Memo

To:	Dale Ortman, P.E.	Date:	May 23, 2011
Copy To:	Chris Garrett, SWCA	From:	Mike Sieber, P.E.
Copy To	SRK, File	Project #:	183101
Subject:	Response to Tetra Tech Memorandum dated 22 April 2011, Infiltration and Seepage Model

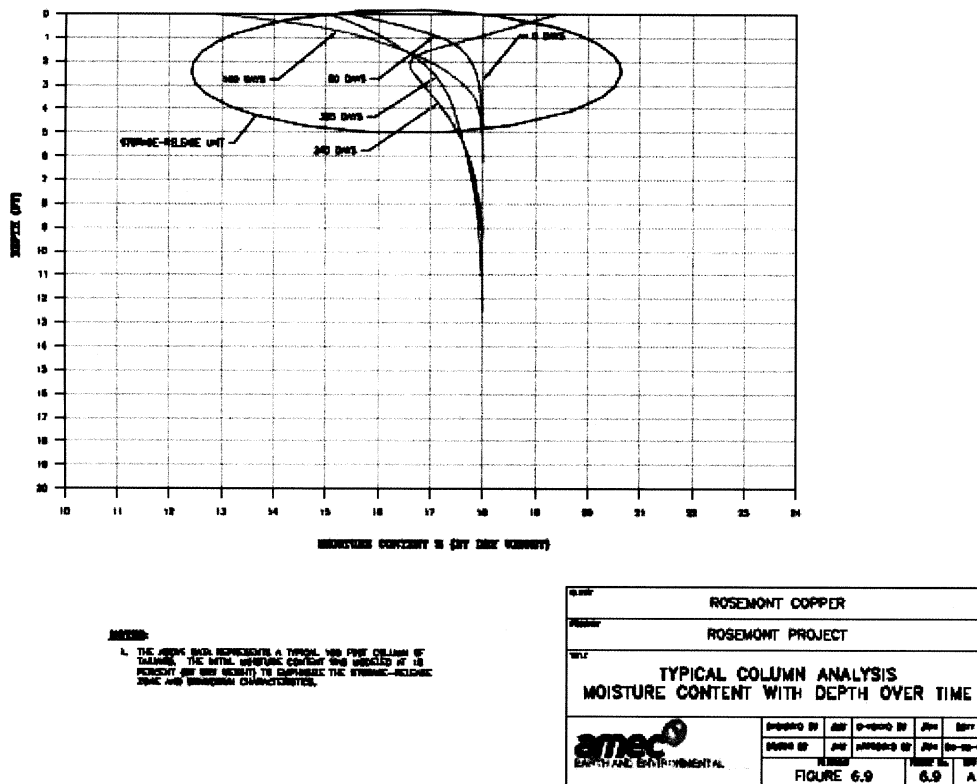
Tetra Tech stated that moisture content and hydraulic properties for site waste materials were provided in the laboratory reports for test work completed by Advanced Terra Testing. The attached laboratory data from Advanced Terra Testing are for geotechnical tests (Atterberg Limits, Proctor, density, sieve analysis etc.). There are no moisture content or hydraulic properties tests in these laboratory reports (porosity, moisture characteristics, saturated hydraulic conductivity, and unsaturated hydraulic properties). Are there are other laboratory reports that provide these data?

AMEC, 2009, Figure 6.9 (Tetra Tech, Figure 5.26)

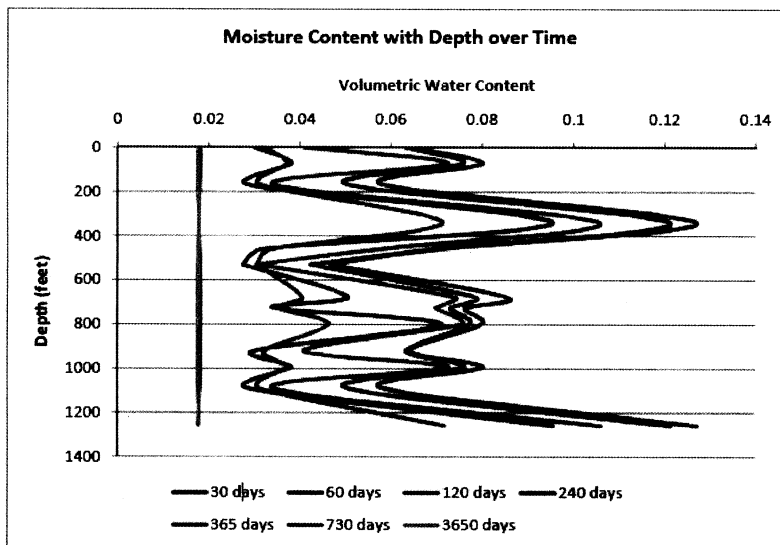
SRK has the following questions about the figure showing moisture content vs. depth:

1. The figure indicates that the heap is 1,400 feet high. Please clarify the depth shown for the height of the Heap.
2. AMEC's Figure 6.9 (2009) (Tetra Tech's Figure 5.26) for the dry stack tailings are what would be expected for an infiltration simulation with one material type, as the Heap Leach simulation was. The drastic change of the slope of the curve seen in the Tetra Tech figure indicates a change in materials with different hydraulic properties. The discontinuity between the first 365 days and 730 and 3650 days indicates that there is something wrong with the model formulation. Again look at Figure 5.26; this illustration is more typical for infiltration models assuming one material type.

Are the results from the simulation for 0 to 365 days used for the model shown for 730 to 3650 days? Was this simulation for the Heap alone or one of the closure options with a waste rock cover?
